ADMINISTRATIVE

APPROVALS

April 02, 2025

**H2.4 SHEAFE STREET ELEVATION
111 STATE STREET**

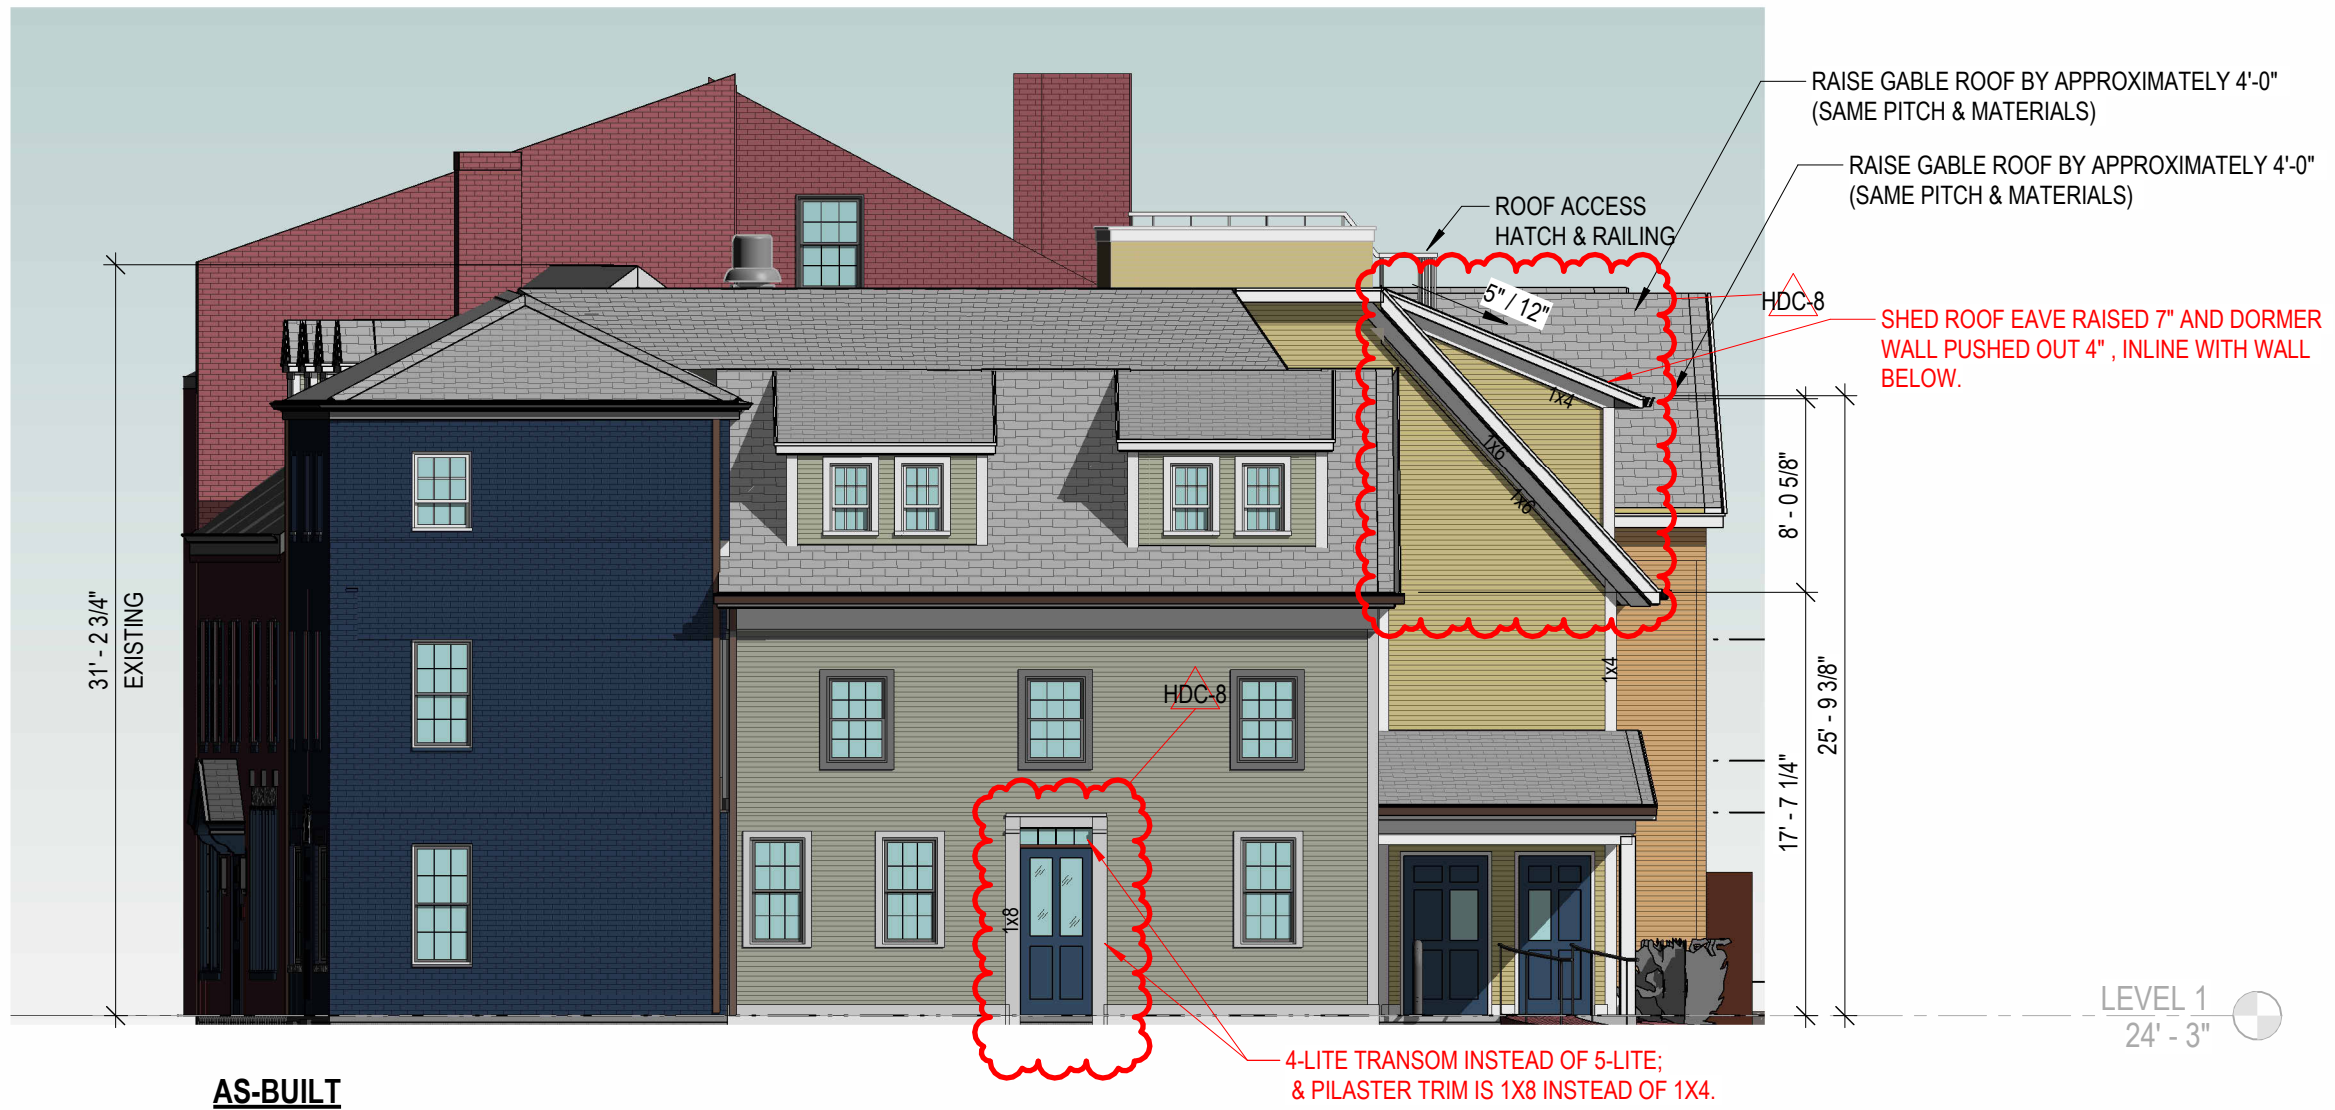
- A. Vertical trim piece omitted at wall below gable valley
- B. Window at gable valley changed from 1/1 to 9/3.
- C. Replace crown moulding on rear gable & rake fascias with 1x2 trim
- D. Frieze trim omitted under gable returns.
- E. Eave at east shed dormer raised 7", wall pushed forward 4"

SOUTH (REAR) ELEVATION - PROPOSED

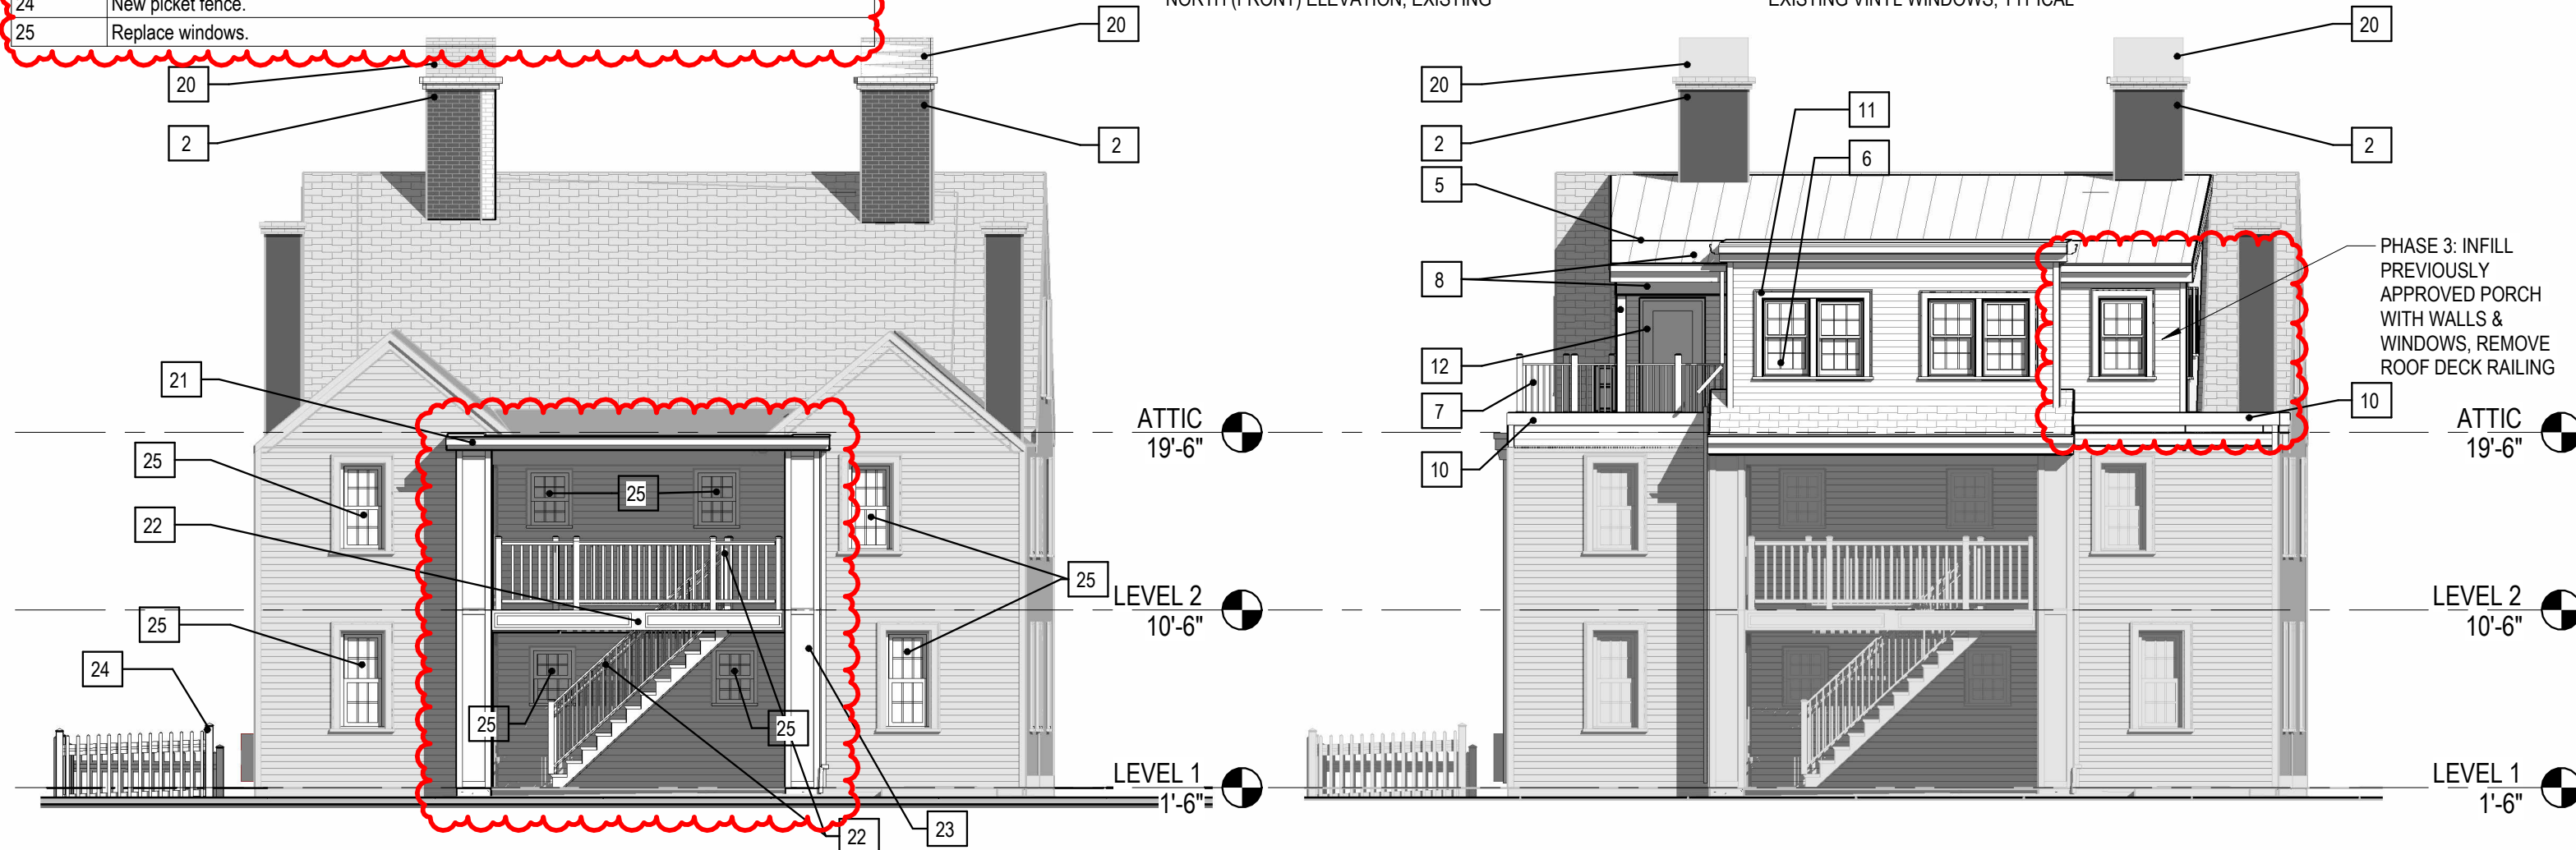
PHASE 3: INFILL PREVIOUSLY APPROVED PORCH WITH WALLS & WINDOWS, REMOVE ROOF DECK RAILING
